Access Compliance Report

(Curb Ramps)

Intersection ID: 52988	Main Street: LANDING_PLACE_LN	Cross Street: GREYTHORNE_DR	Location: NE
ADA ID: E0BC14EAC372	Ramp Type: BlendTrans1	Initial Pass/Fail: Fail	Overall Compliance: No
Severity Score: 12.5			
Codes/Mitigation Info/Possible Solution		Field Measurements/Component Compliance

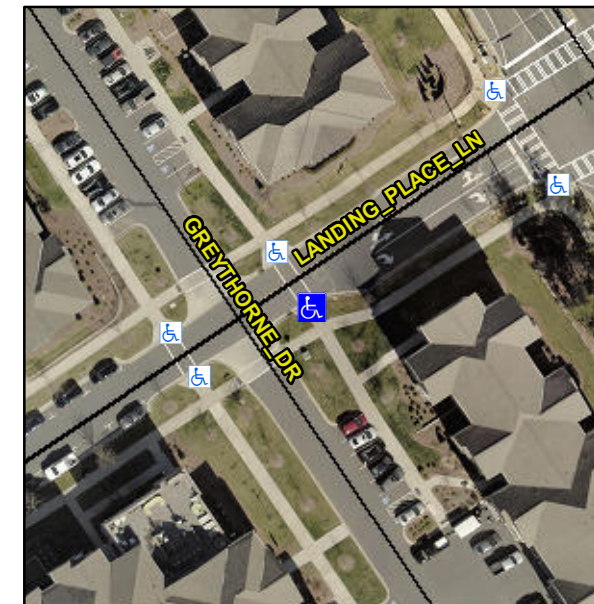
Remove & Replace Curb Ramp With Two New Directional Ramps or Equivalent.

Not Found, R304.5.3
